STATE OF MAINE  
DEPARTMENT OF TRANSPORTATION  
16 STATE HOUSE STATION  
AUGUSTA, MAINE 04333-0016

February 22, 2023  
Subject: Frank J. Wood Bridge  
Replacement  
State WIN: 022603.00  
Location: **Brunswick & Topsham**  
**Amendment No. 1**

FRANK J. WOOD BRIDGE  
ANDROSCOGGIN RIVER  
BRUNSWICK-TOPSHAM  
CUMBERLAND  
LIGHTING PLAN

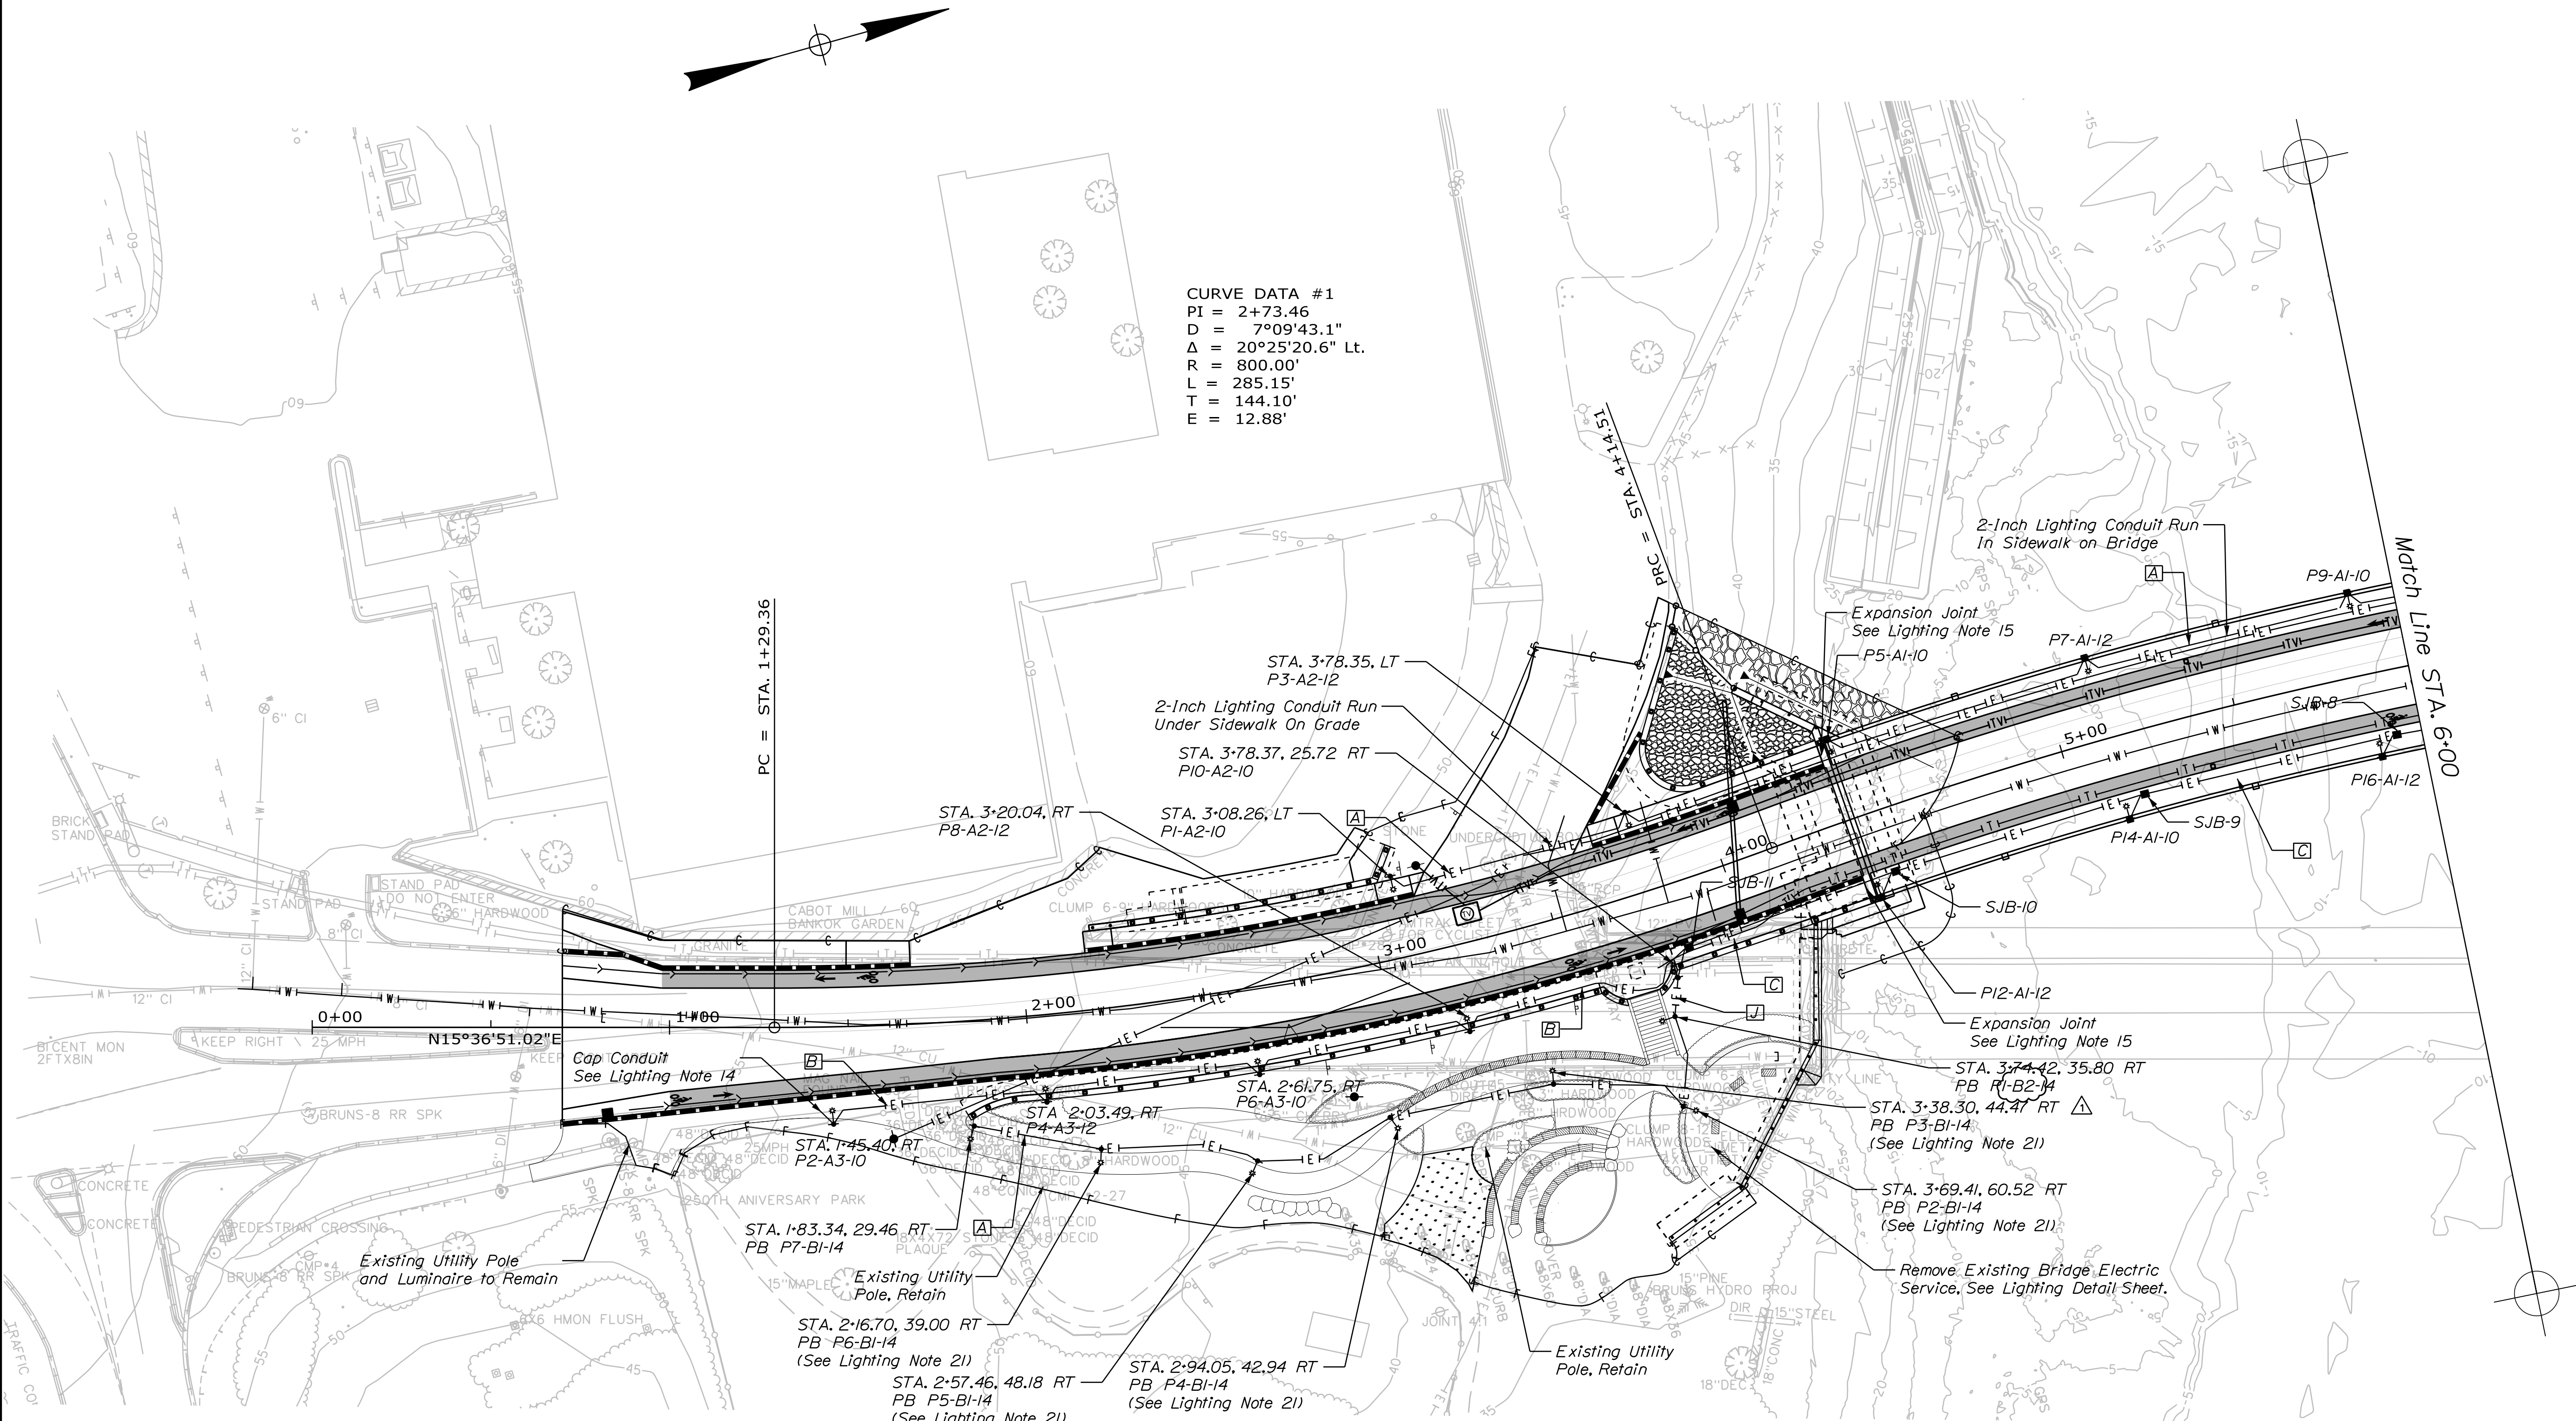
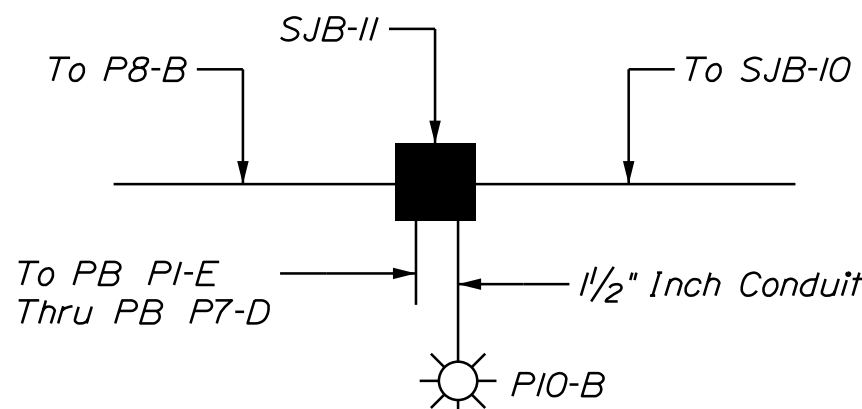
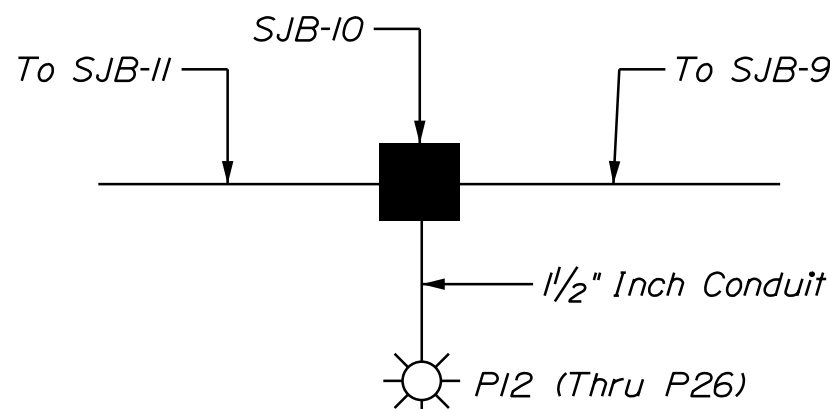
**REMOVE** sheet 157, LIGHTING PLAN, 1 sheet dated 8/20 and **REPLACE** with attached sheet 157A, LIGHTING PLAN, 1 sheet dated 2/16/2023.

**Question:** Drawing 160 "Pole Schedule" indicates 6 each Type B1, and 2 each Type B2 Poles/fixtures, however the lighting plan drawings 157-159 indicate 7 each Type B1 and 1 each Type B2. Please verify which is correct.

**Question:** Drawing 157 Lighting Plan. Wire Schedule "J". Appears to begin at SJB-11 and proceed to PB P1-B1-14. Please indicate how far circuit configuration "J" proceeds from there, as there are not any letter designations past this pole.

**Question:** Drawings 157 Lighting Plan indicates Wire Schedule "C" to consist of #3 awg conductors. Drawing 158 and 159 indicates these are to be #2 awg conductors. Please clarify which is correct.

**Response:** See above changes to the bid documents.

**Response:** Wire schedule item “J” being at SJB-11 and end at PB PR-B1-14.

**Response:** Wire Schedule item “C” contains #2 awg conductors for the extents of sheets 158 and 159 until SJB-8 on Sheet 157.

SHEET NUMBER  
T-1  
OF T-7

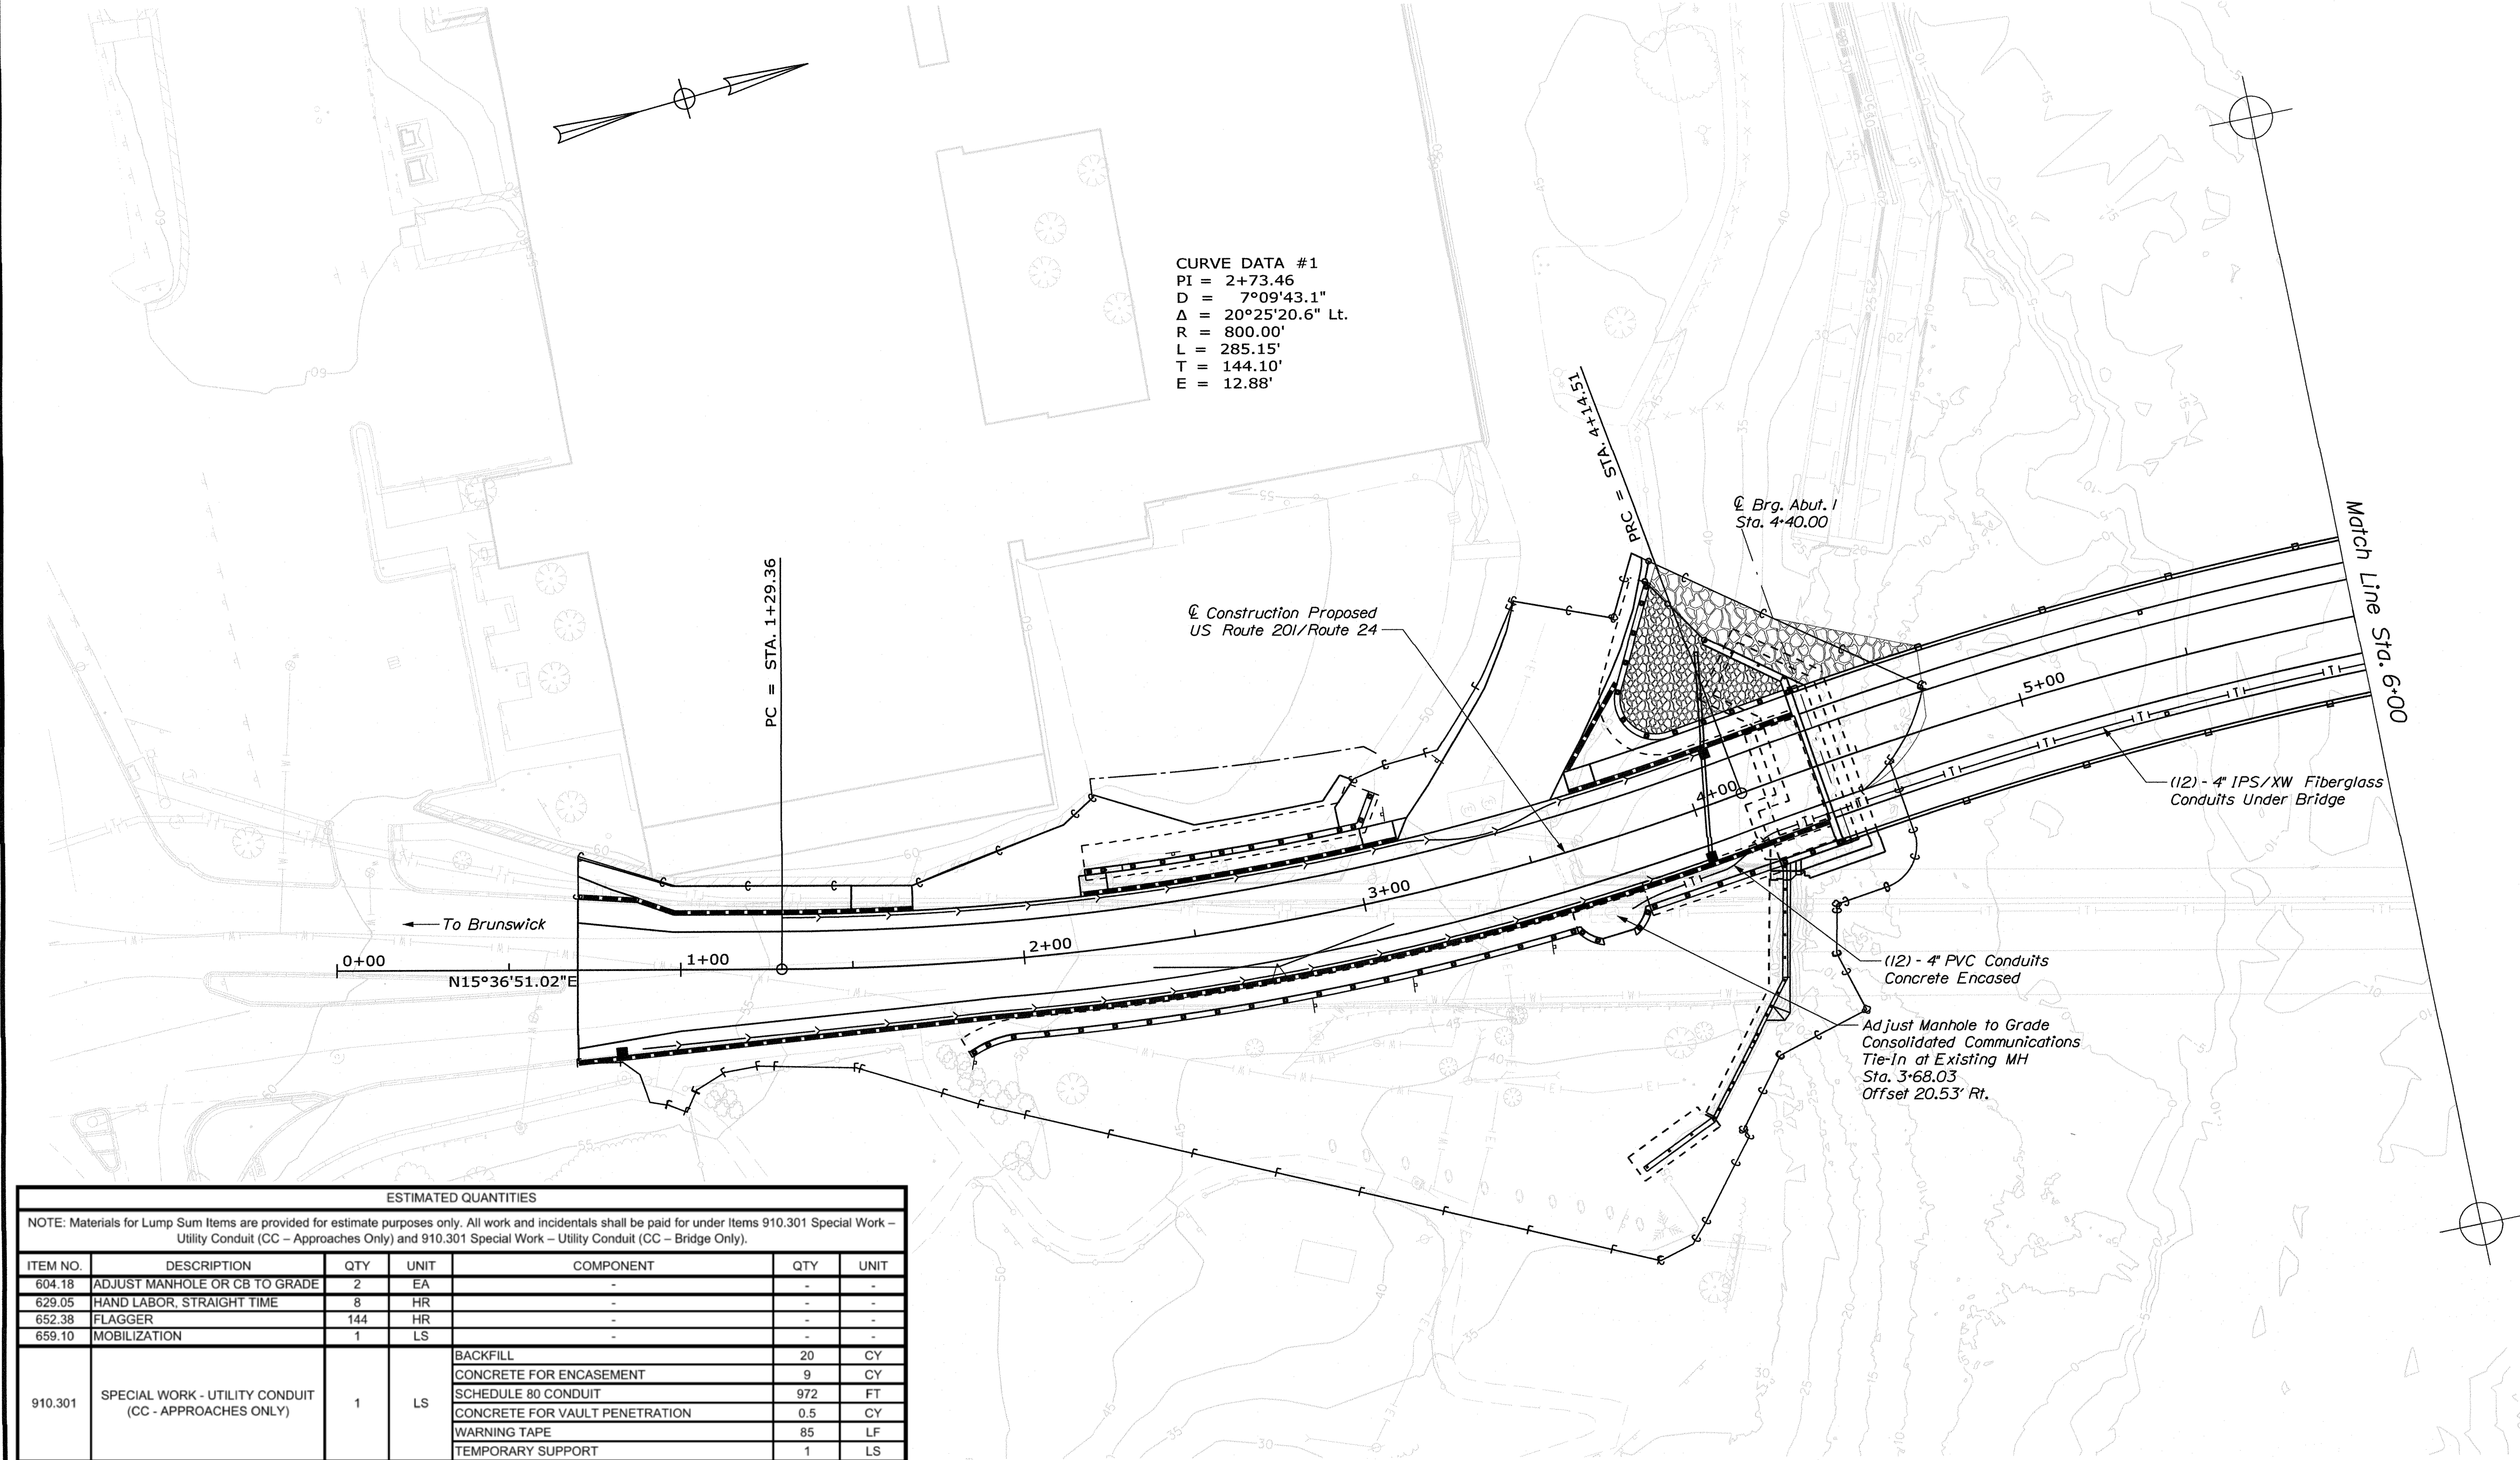
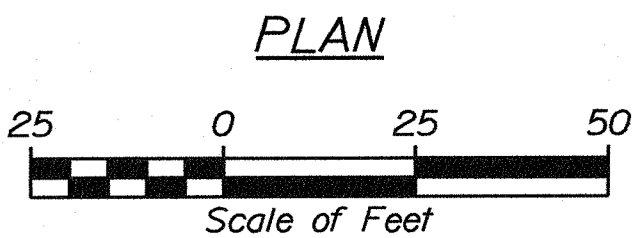
**REMOVE** sheet T-1, CONDUIT LAYOUT PLAN 1, 1 sheet dated 1-3-22 and **REPLACE** with attached sheet T-1, CONDUIT LAYOUT PLAN 1, 1 sheet dated 1-3-22.

**Question:** "T" Drawings-Consolidated conduits. Please provide an Estimate of Quantities/ Bill of Materials similar to what is shown for the CMP and the Comcast, First Light, GWI conduits & supports.

**Response:** See the above changes to the bid documents.
